Response to comments #2:

Technical Note: Sensitivity of instrumental line shape monitoring for the ground-based high resolution FTIR spectrometer with respect to different optical attenuators.

Fig.1 (a) ME and (b) phase error, dark line: default scenario; red line: placing an attenuator or aperture into the parallel beam between the sun and the first plane mirror

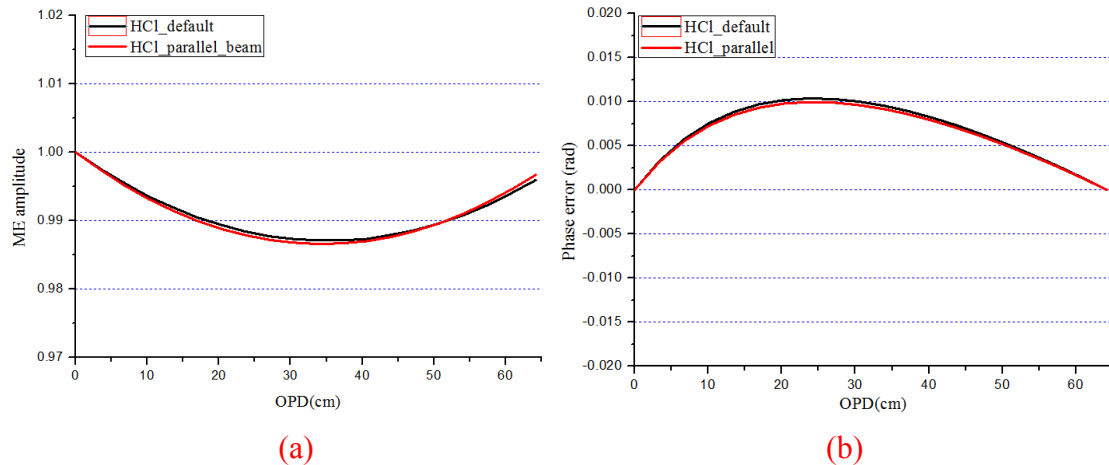
For the content, I agree with all the points raised by referee #1. In addition, I wonder why the authors did not test the effect of placing an attenuator or aperture into the parallel beam between the sun and the first plane mirror. This is a setup that is used for all the TCCON instruments built by Caltech (fixed-size aperture) as well as the instrument on Ascension Island (iris aperture). As far as I know, the instrument in Bremen is fully operational and such an additional experiment should only take a day or so. It can be done without even opening the instrument.

Response: The setup that fixing the aperture and placing an attenuator or aperture into the parallel beam between the sun and the first plane mirror belongs to the scenario that inserting attenuators # 1~4 in front of the interferometer in this paper. I don't think it is necessary to include this setup in the revised paper.

Actually, with Hefei instrument, we compared the default scenario (aperture is fixed at 1mm size and don't insert any attenuators) with the scenario that inserting the attenuator #2 between the sun and the first plane mirror. The ILS modulation efficiencies and phase errors deduced from the two scenarios are shown as following figure. Consistent ILS retrievals of the two scenarios were achieved. This finding could apply to all TCCON instruments since Hefei run the same instrument as other TCCON site. We did not include these results into the paper to avoid instrument to
